## City Planning Department

## Memo

To: Cranston City Plan Commission  
From: Joshua Berry, AICP, Senior Planner / Administrative Officer  
Date: December 31, 2020  
Re: "Natick Avenue Solar" Preliminary Plan – Major Land Development

# EXISTING CONDITIONS PLAN WITH SLOPES OVER 15%

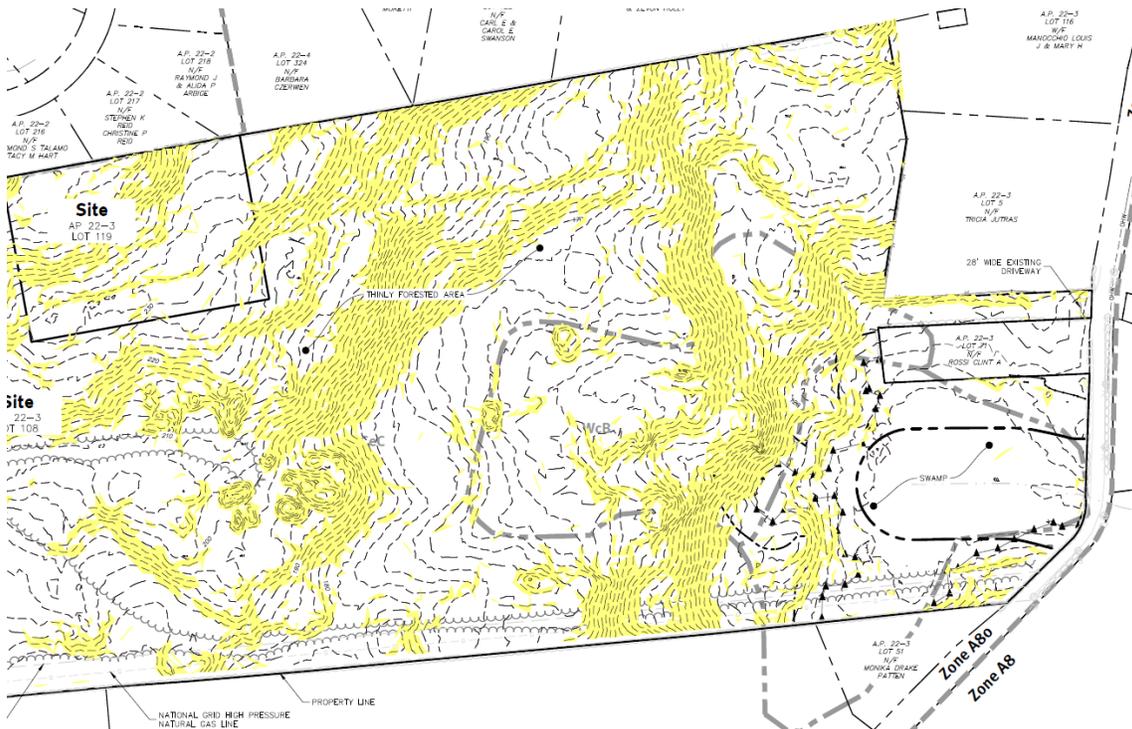
On the following page exhibits are provided to compare the Existing Conditions Plan (sheet 4 of the Full Plan Set) to the Cut-Fill Exhibit. One can observe that that the proposed areas of cut and fill have been minimized to the areas with the steepest slopes on the site and for installation of drainage facilities. Therefore, **staff finds that the applicant is in compliance with Master Plan Condition #7 in terms of following existing grades as much as possible.**
